Morris Goding
Access Consulting

60-70 Horace Street, St. Ives -
St. Ives Indoor Sports
Complex

**Access Review –
DA Final v3**

25 October 2021

7.1 Paths of travel

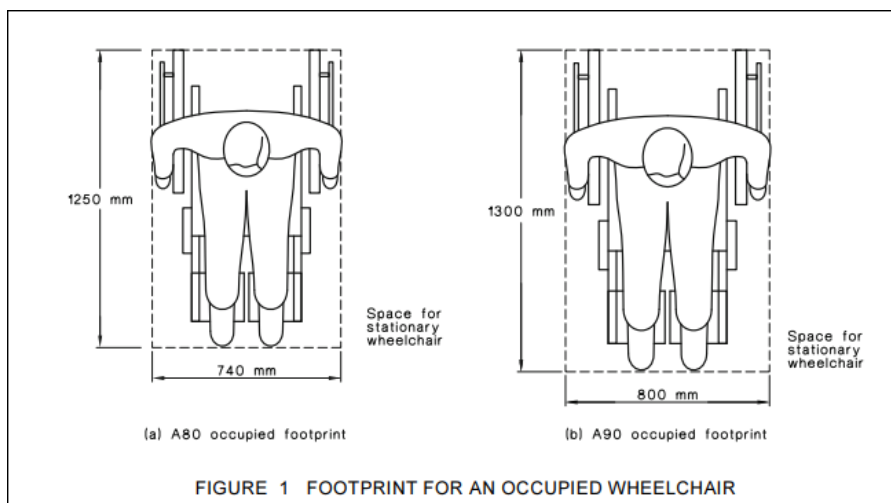
- Hardwood full height feature located at the lower ground floor should be considered for provision of 30% luminous colour contrast against the background surface. Proposed design is capable of achieving compliance.

7.6 Public Domain – Kerb Ramp

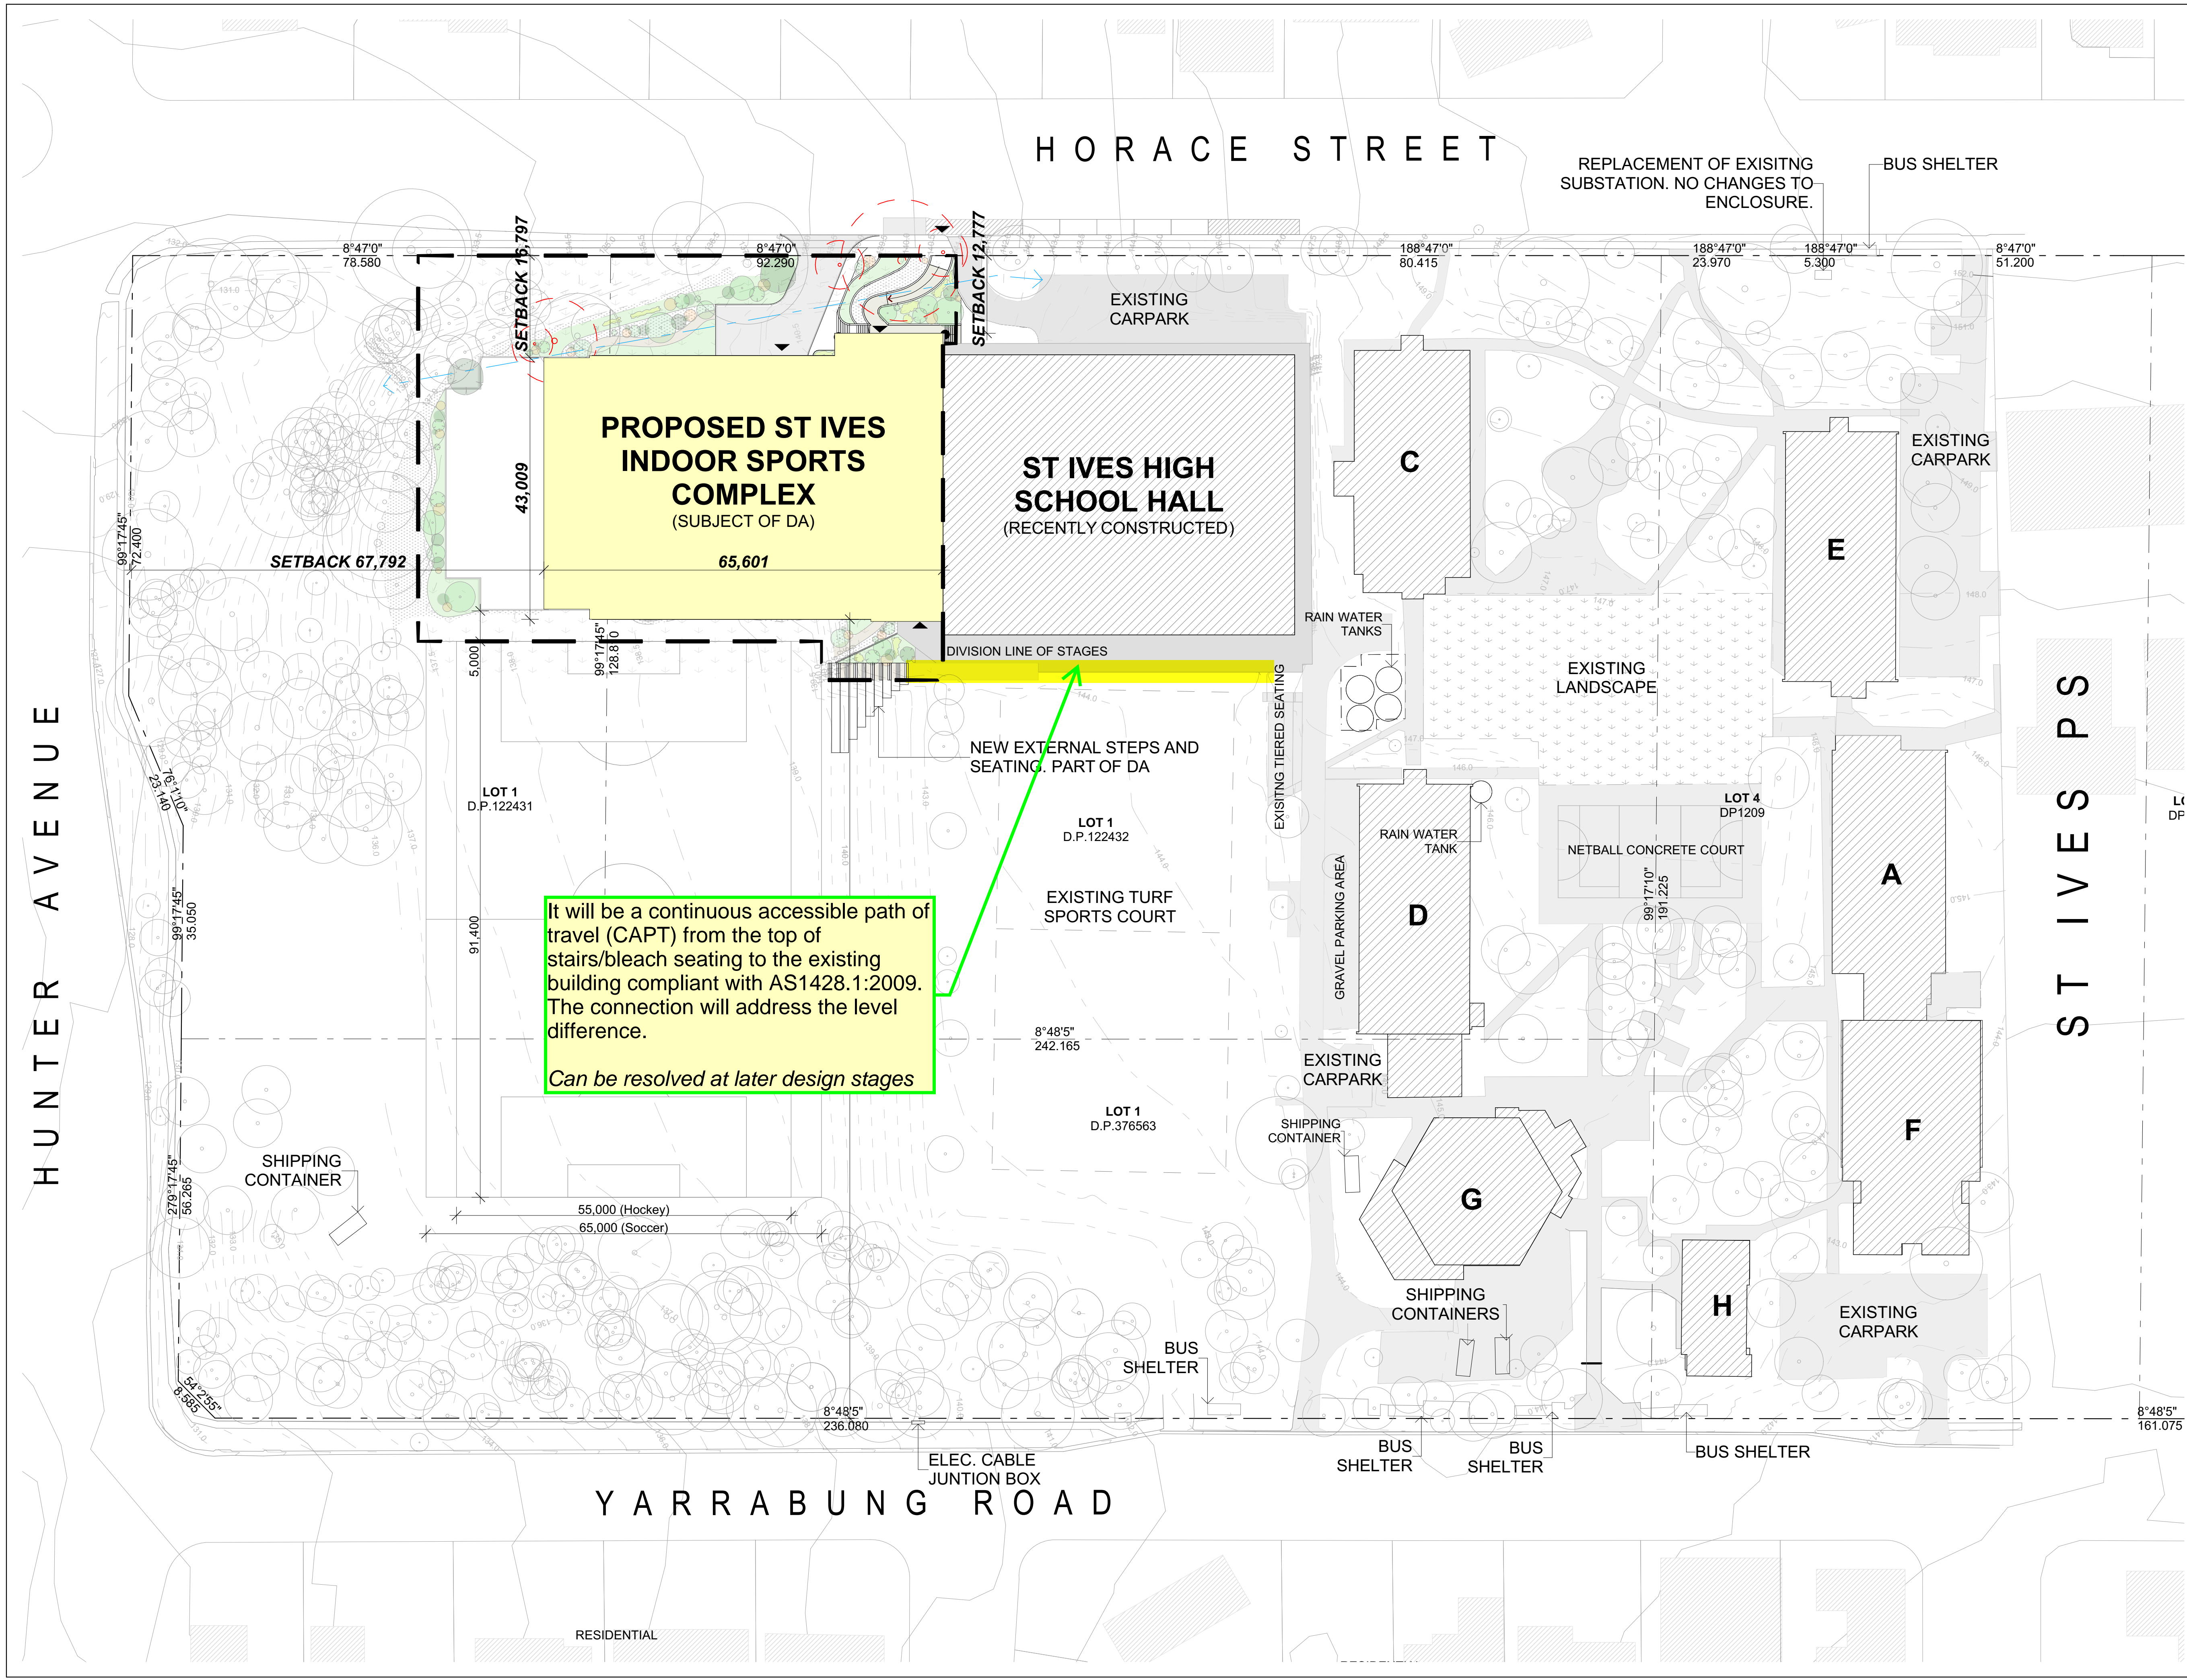
- Ensure proposed new kerb ramps are designed in accordance with technical Manual (Public Domain) Local council kerb ramp standard details.

Proposed design is capable of achieving compliance.

LOWER GROUND FLOOR PLAN

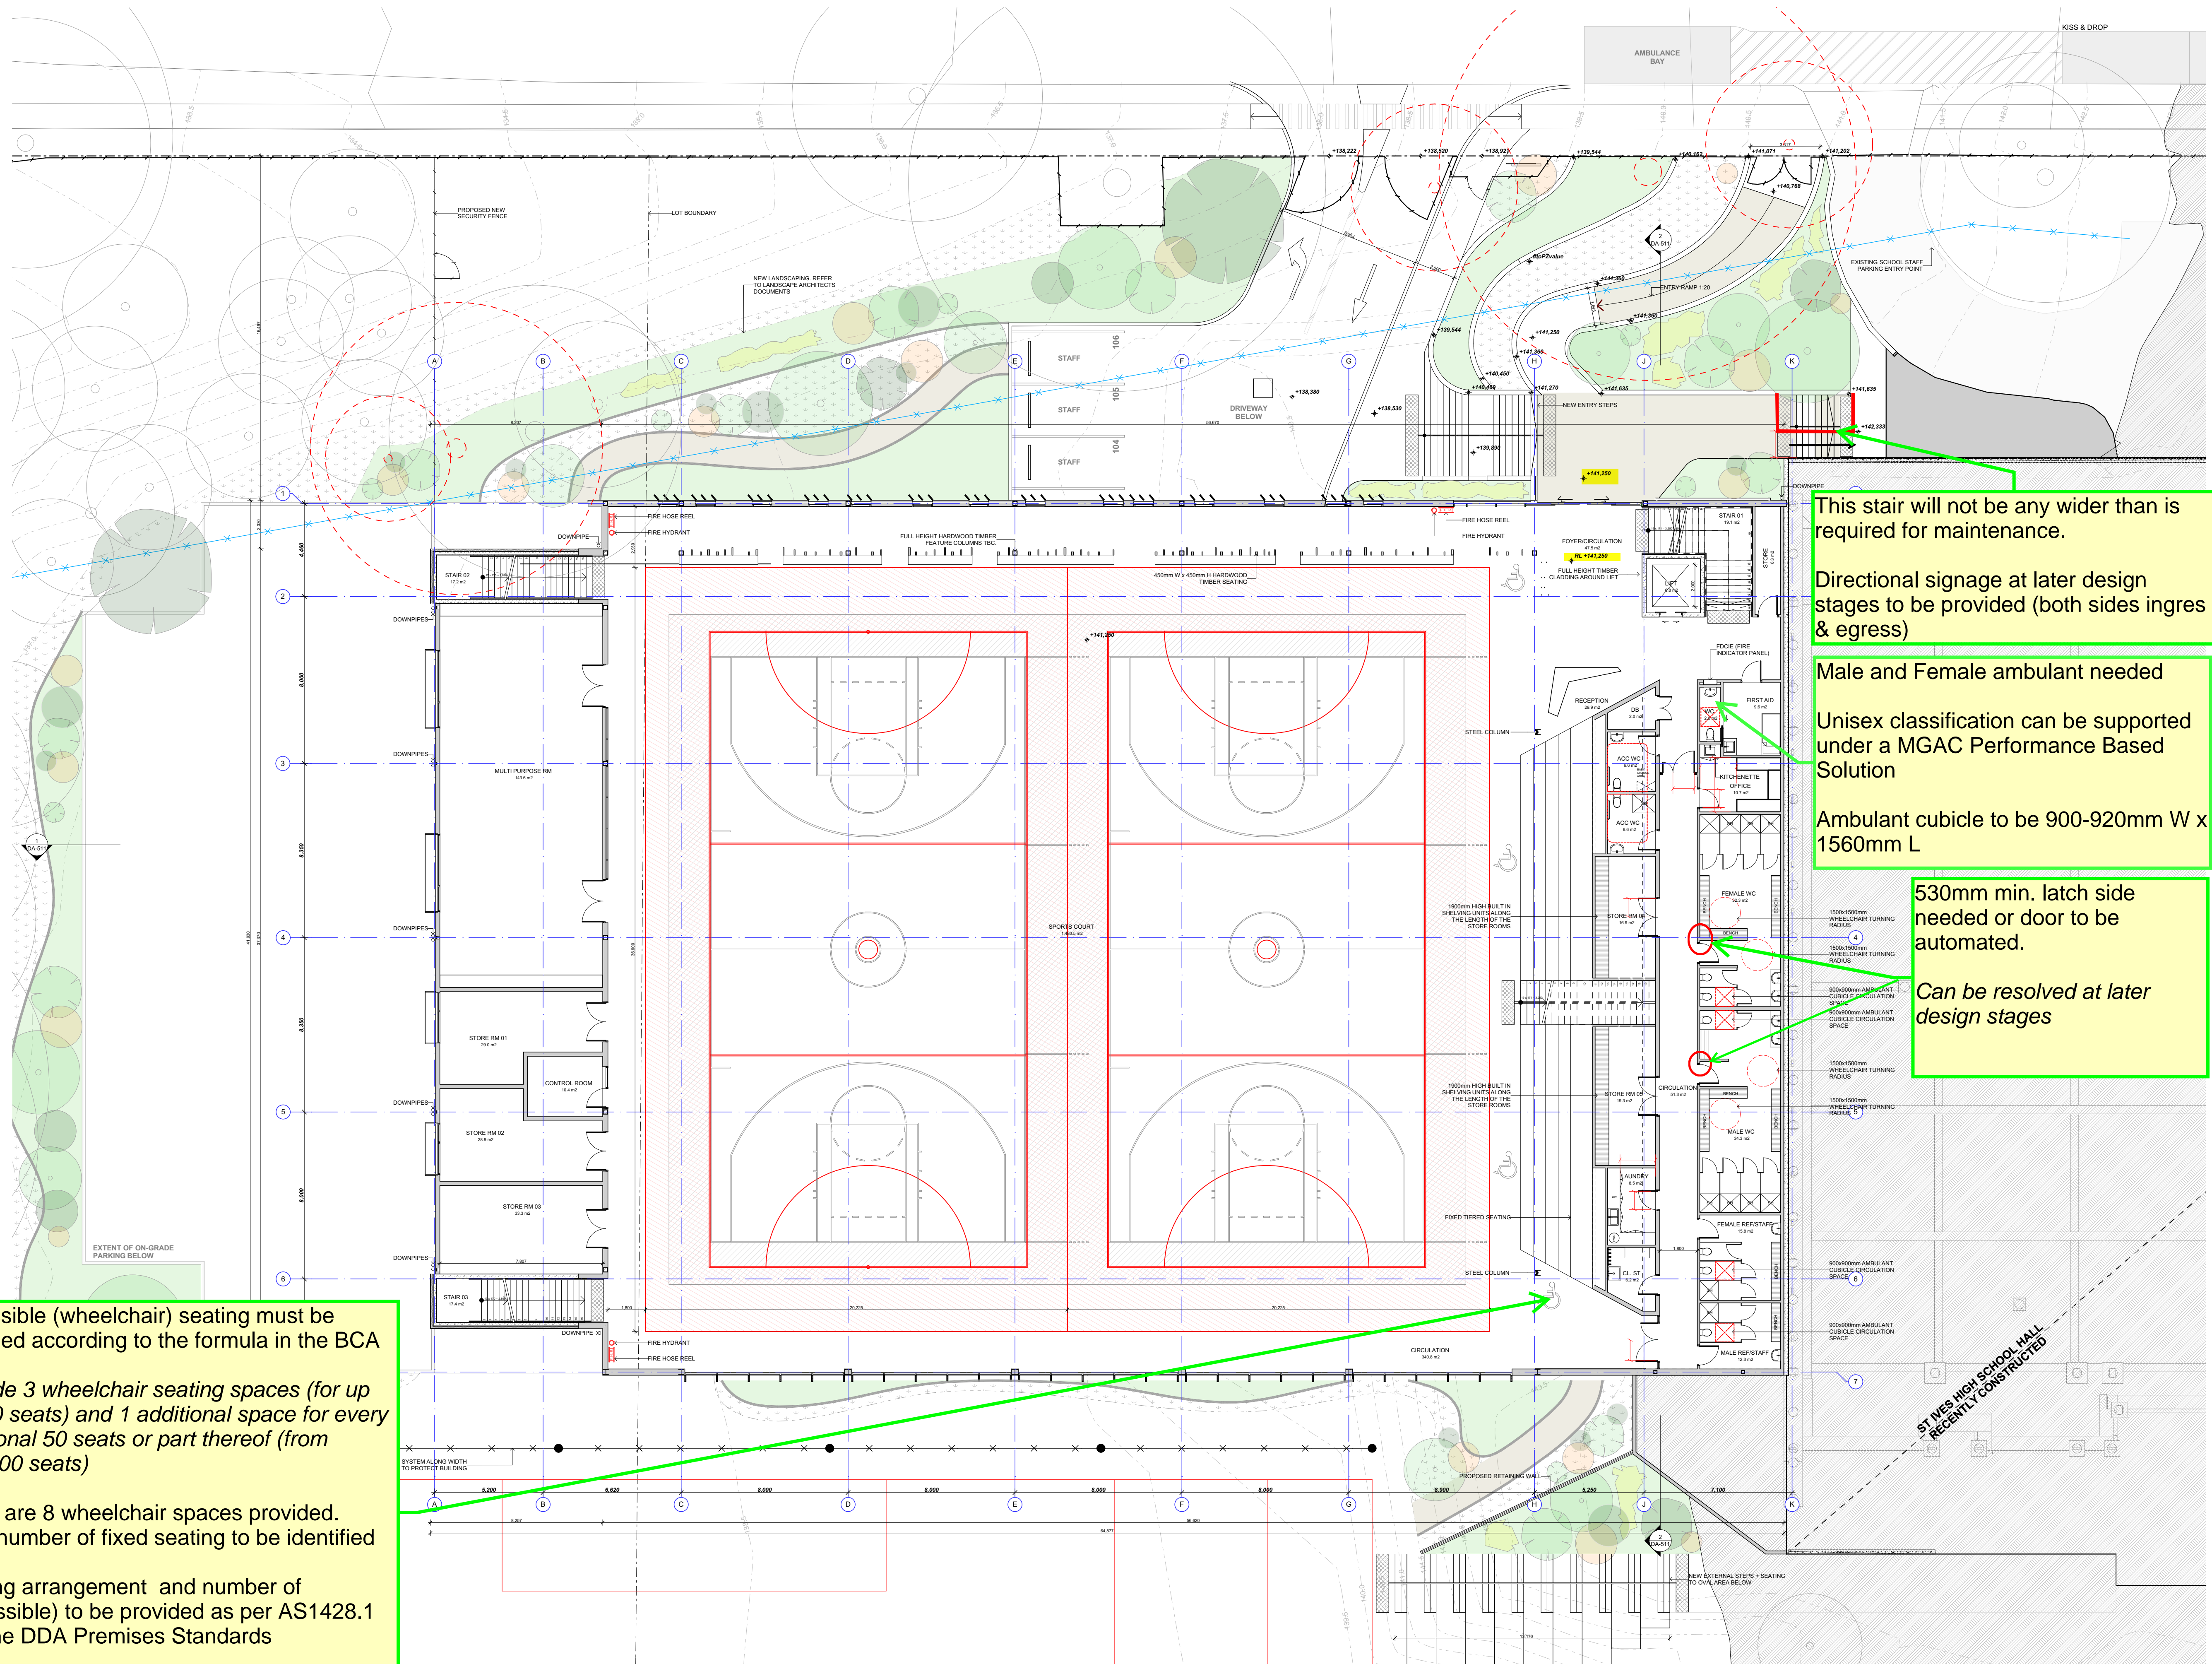
Accessible (wheelchair) seating must be provided according to the formula in the BCA

Provide 3 wheelchair seating spaces (for up to 150 seats) and 1 additional space for every additional 50 seats or part thereof (from 150-800 seats)

There are 8 wheelchair spaces provided. Total number of fixed seating to be identified

Seating arrangement and number of (accessible) to be provided as per AS1428.1 and the DDA Premises Standards

This stair will not be any wider than is required for maintenance.

Directional signage at later design stages to be provided (both sides ingress & egress)

Male and Female ambulant needed

Unisex classification can be supported under a MGAC Performance Based Solution

Ambulant cubicle to be 900-920mm W x 1560mm L

530mm min. latch side needed or door to be automated.

Can be resolved at later design stages.

Can be resolved at later design stages
